Change in Geometry

between

Prod-04-00 and Prod-04-01

# Identical macro run 1e5 neutrons using different version of DOGS

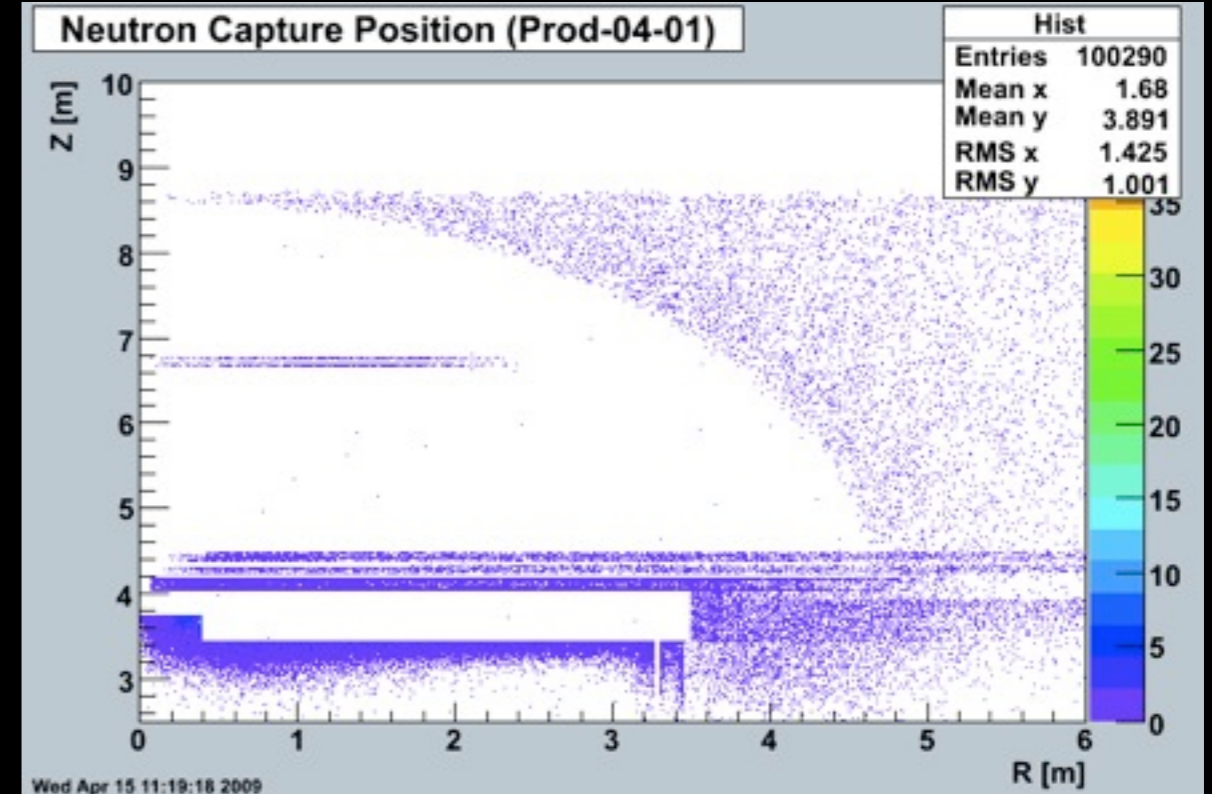
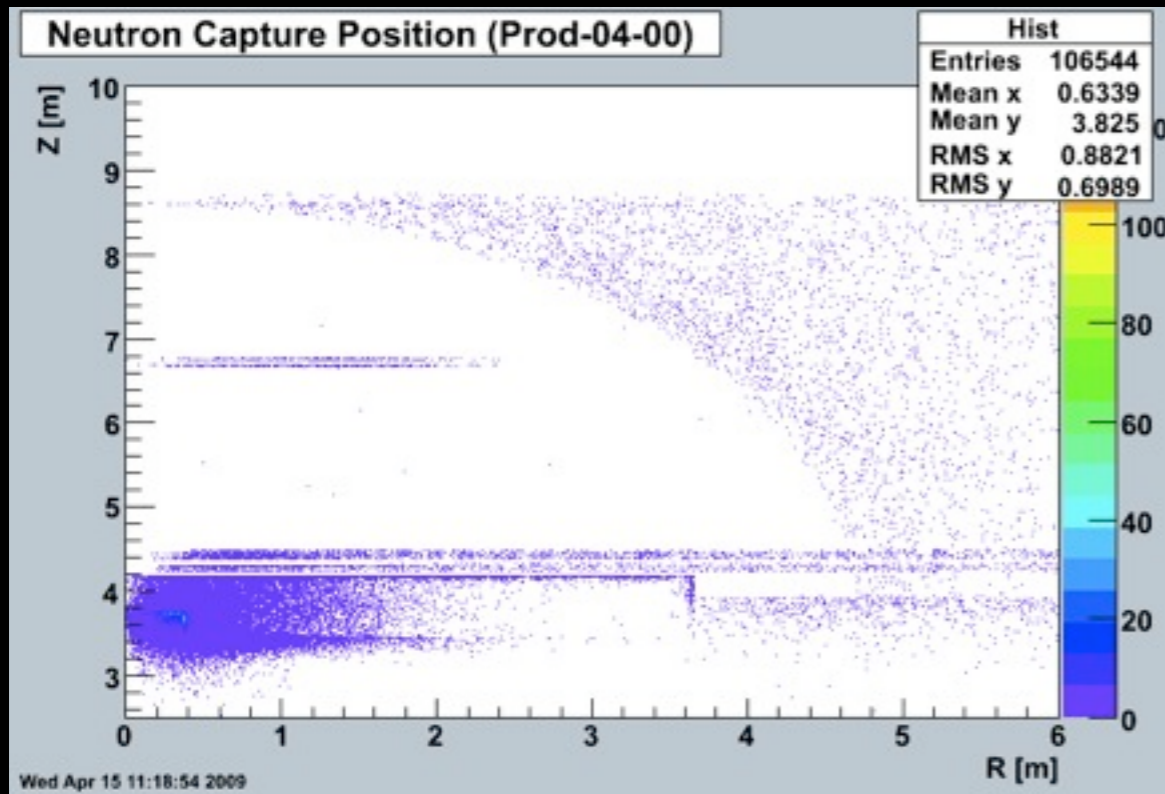
Right : Neutron capture position using **Prod-04-00**

Left : Neutron capture position using **Prod-04-01**

The **left (Prod-04-01)** plot has lots of neutron capture throughout the region from the IV tank to dorm floor. This region is supposed to be filled with air....

(Prod-04-00)

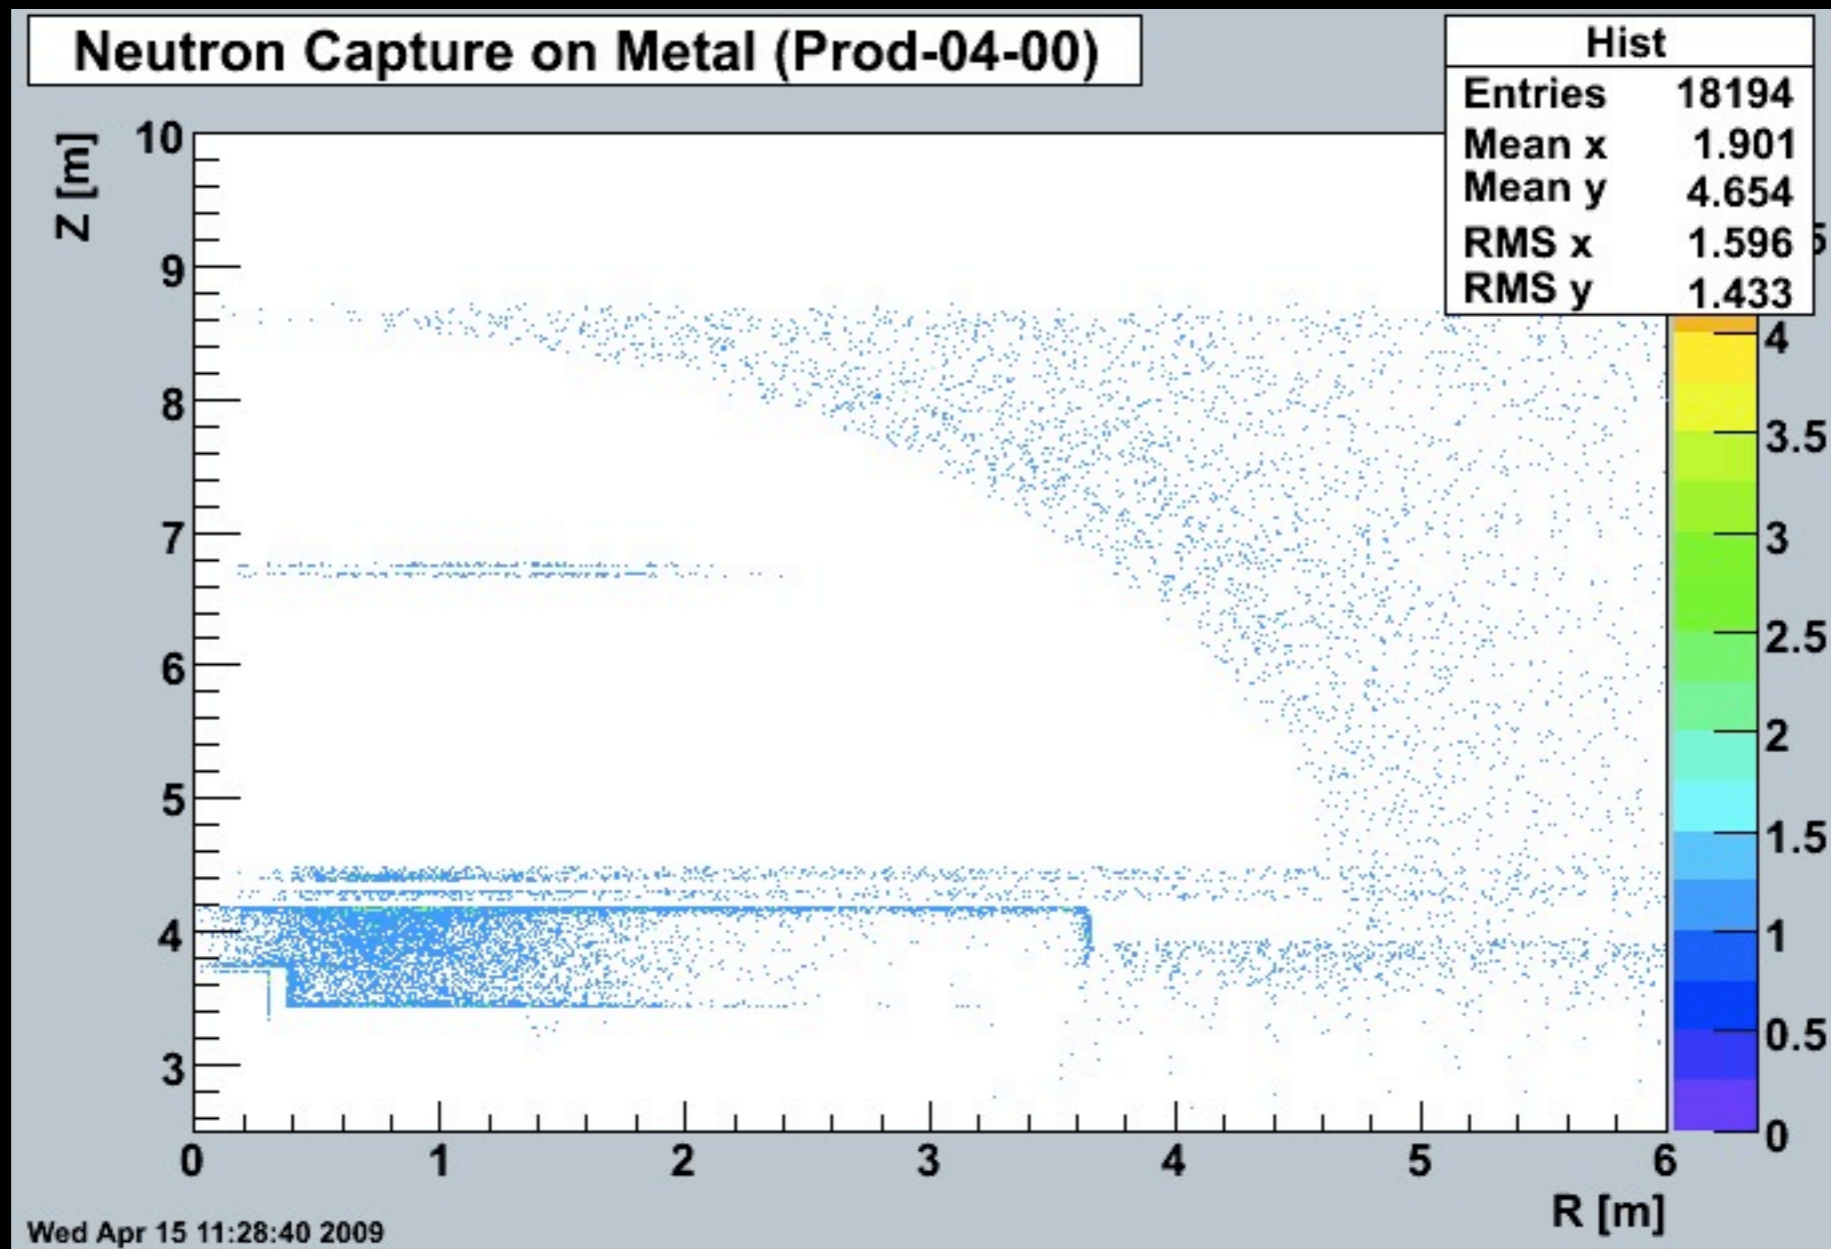
Let's look at metal nucleus

tagged with

neutron capture event

Similar simulation with  $1e4$  neutrons...  
(slightly different starting position)

Tagged capture metal position  
(Prod-04-00)

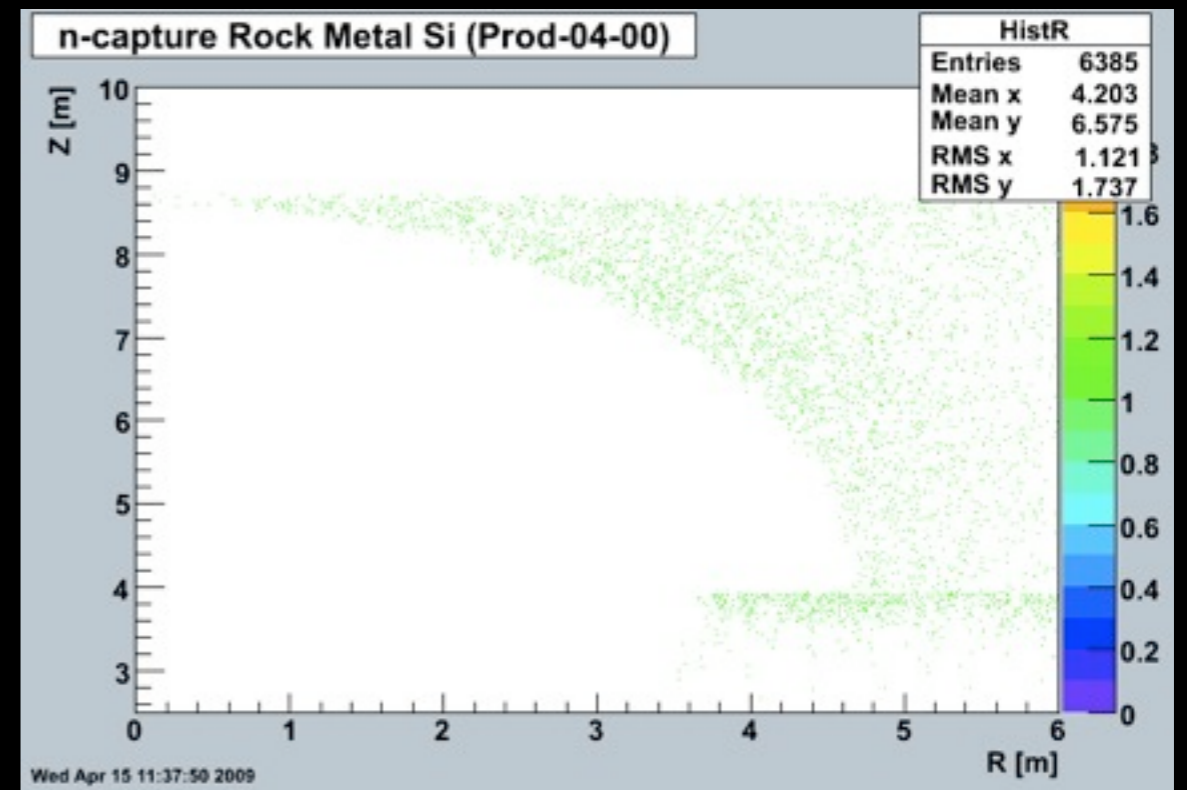
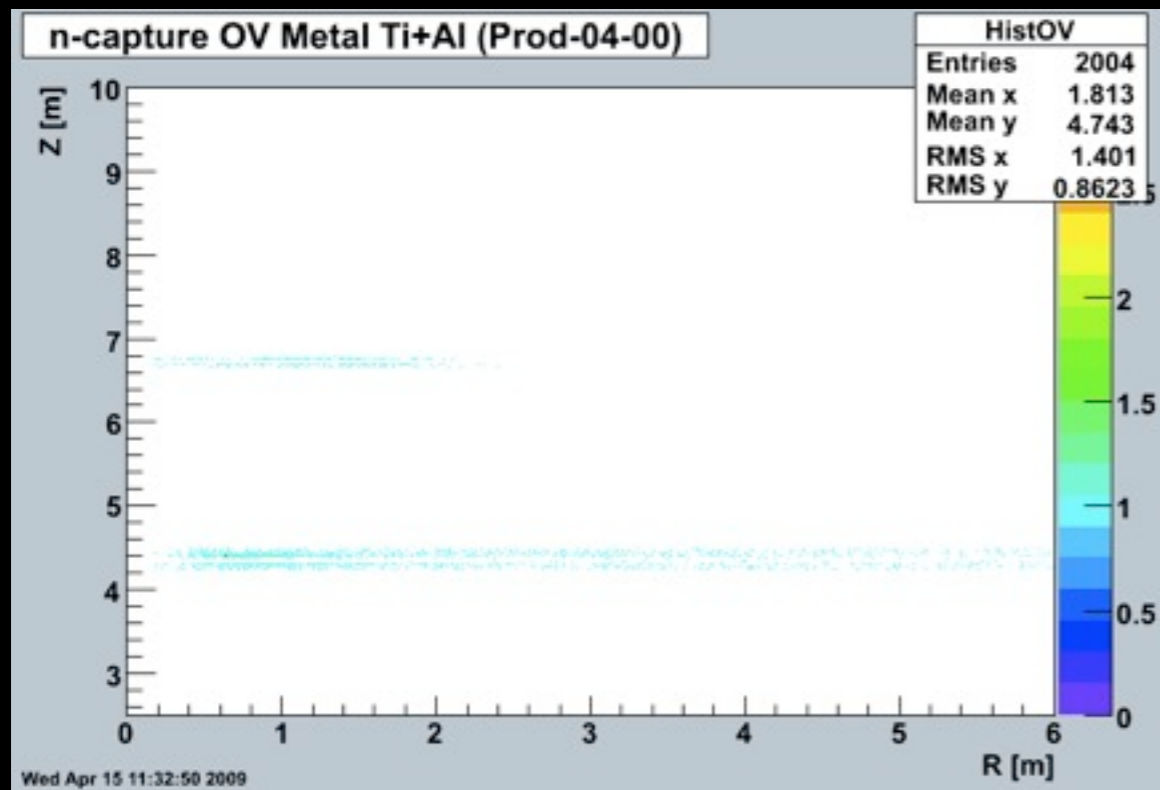
# We can identify capture metals nucleus

From DCGLG4sim geometry construction....

- **Rock Metal** elements = **Si**
- **OV Metal** elements = **Ti + Al**
- **Shield + Tank Metal** elements = **Fe + Ni + Cr**

## Shield Tank Metal capture ( Fe + Ni + Cr )

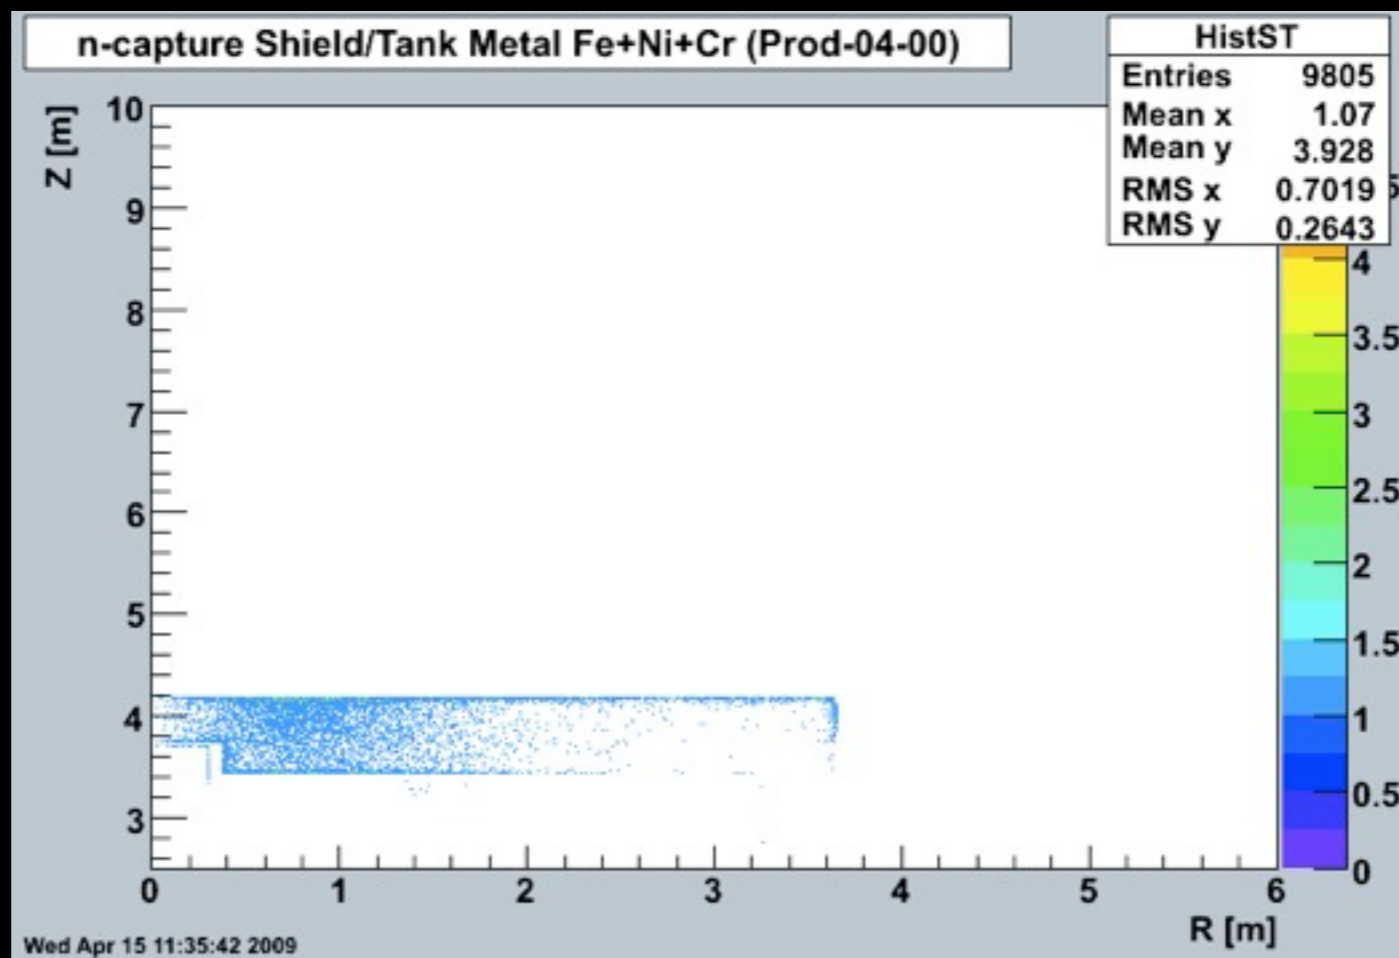
**Conclusion:** it seems that the volume between IV tank to the dorm floor is filled with stainless steel in the DCGLG4sim geometry of Prod-04-00. Is this a bug?
